PERMITS 19164 AND 19165 (APPLICATIONS 26306 AND 26307) SHASTA RIVER IN SISKIYOU COUNTY

On April 17, 2001, I met with watermaster Keith Dick to view the installation and operation of the measuring devices (rectangular orifices in flashboards) installed to comply with term 16 of the above permits. These devices are to provide the required bypass flows for the gravity diversion and the pumped diversion serving the Hole-in-the-Ground Ranch.

Shasta River Pumped Diversion No. 166

Shasta River Gravity Ditch Diversion

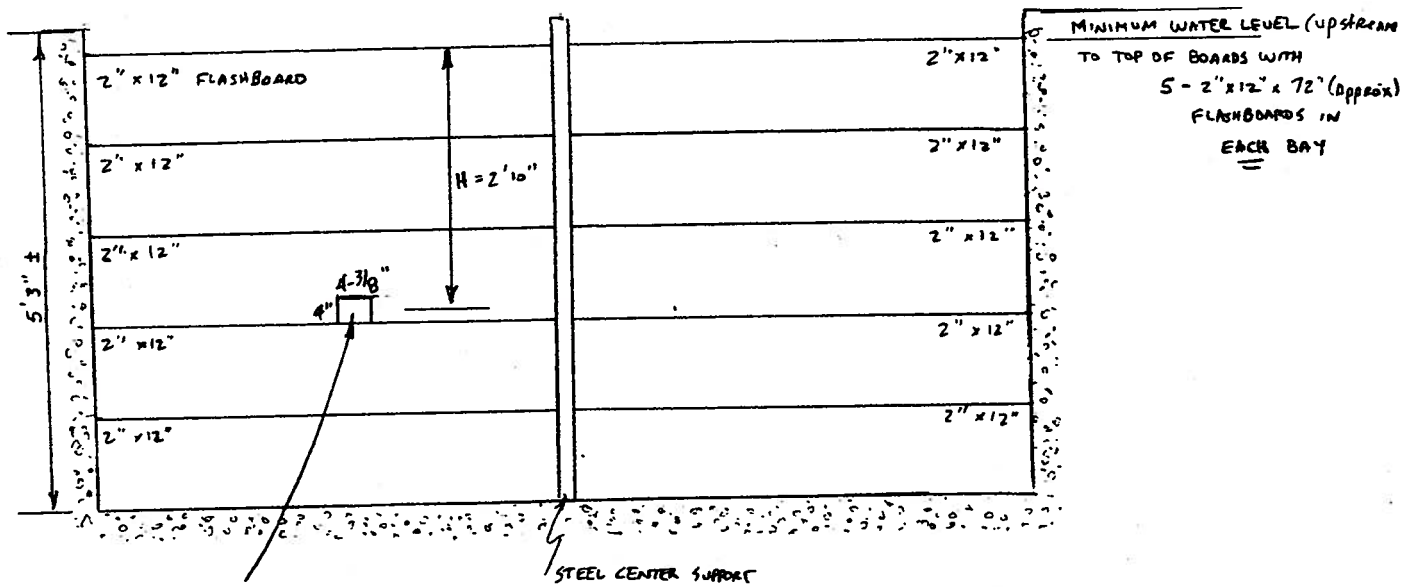
Discharge through Rectangular Orifice

$$Q = 0.61 A \sqrt{2gH}$$

$$A = 4" \times 4\frac{3}{8}" = 17.5 \text{ in}^2 = 0.122 \text{ ft}^2$$

$$Q = 0.61 \times 0.122 \sqrt{64.4 \times 2.833}$$

$$H = 2'10" = 2.833'$$

ORIFICE NOTCH MUST

BE SIZED 4" x 4- $\frac{3}{8}$ " with two 2" x 12" BOARDS BELOW AND

TWO 2" x 12" BOARDS ABOVE BOARD WITH NOTCH

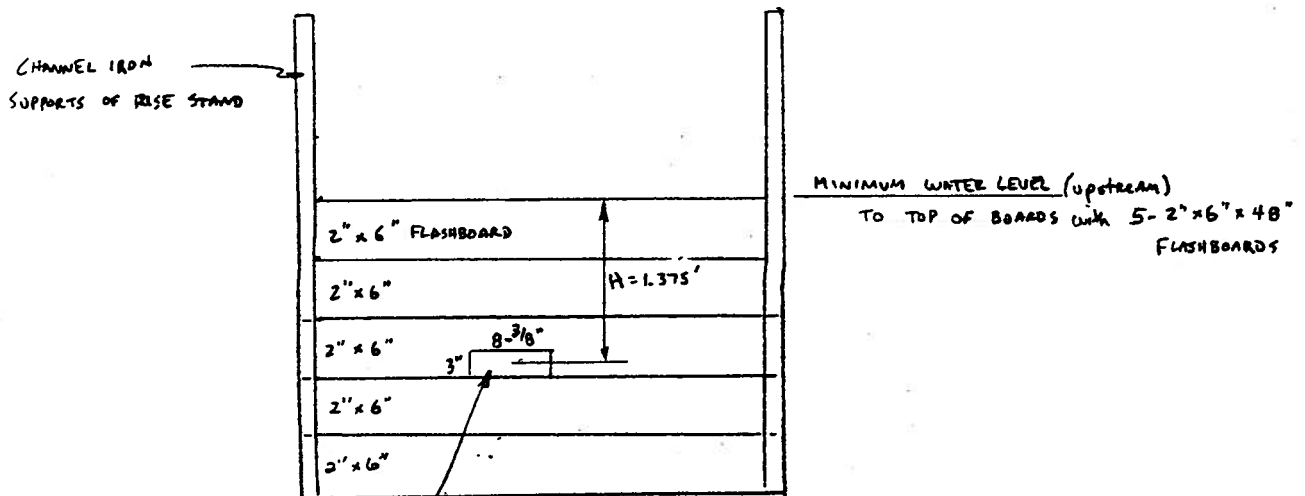
Discharge through Rectangular orifice

$$Q = 0.61 A \sqrt{2gH} \quad A = 3'' \times 8\frac{3}{8}'' = 25 \text{ in}^2 = 0.174 \text{ ft}^2$$

$$Q = 0.61 \times 0.174 \sqrt{64.4 \times 1.375} \quad 2g = 64.4$$

$$Q = 1.0 \text{ cfs} \quad H = 1.375'$$

ORIFICE NOTCH MUST BE SIZED 3" x 8 3/8"

WITH TWO 2x6" BOARDS BELOW AND TWO 2x6" BOARDS ABOVE
BOARD WITH NOTCH

PERMIT 19165 (A-26307)
4-17-01
WCS

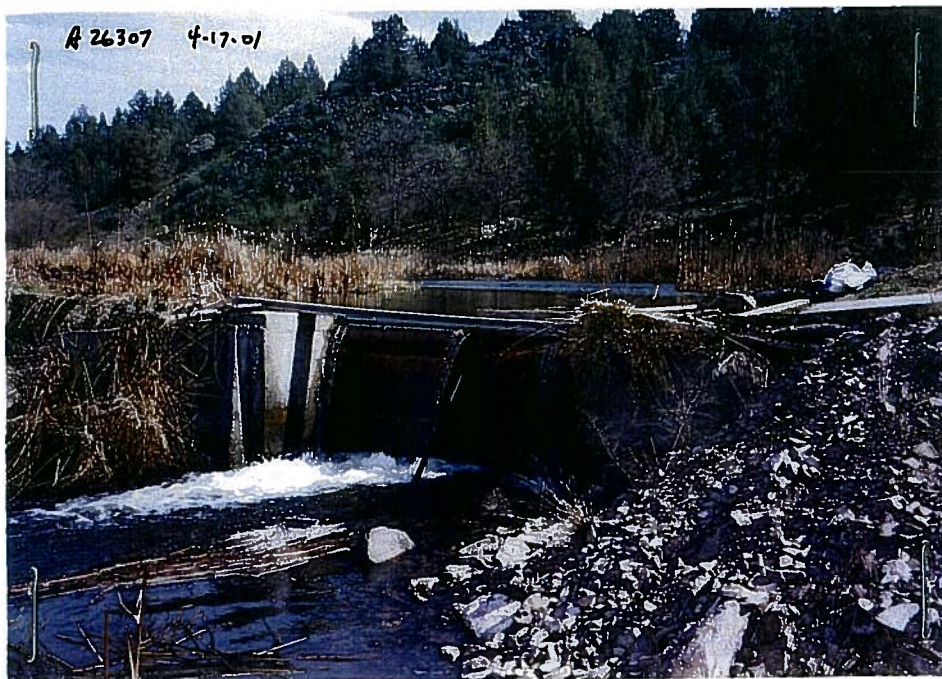
ORIFICE IS IN BOTTOM BOARD
OF RIGHT SIDE BAY
(WITH POUR-OVER) AND
IS SUBMERGED
